Access Compliance Report

Public Rights-of-Way

| Intersection ID: 3806 | Main Street: BRIARCREST_CT | Cross Street: CHESTNUT_KNOLL_LN | Location: E |
| ADA ID: 7D79FB900D8F | Ramp Type: Perp | Initial Pass/Fail: Fail | Overall Compliance: No |

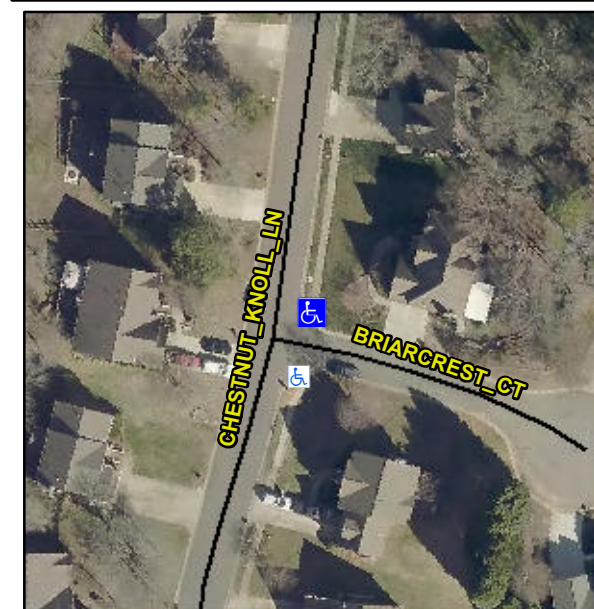
Not Found, R304.5.1, R304.5.3

| Compliance | Description | Data | Compliance | Description | Data |
|------------|-----------------------|-------|------------|-----------------------------|------|
| N/A | Ramp Length (in) | 47.0 | Yes | Ramp Slope (%) | 5.2 |
| No | Ramp Width (in) | 46.0 | No | Ramp XSlope (%) | 6.9 |

Remove & Replace Entire Ramp.
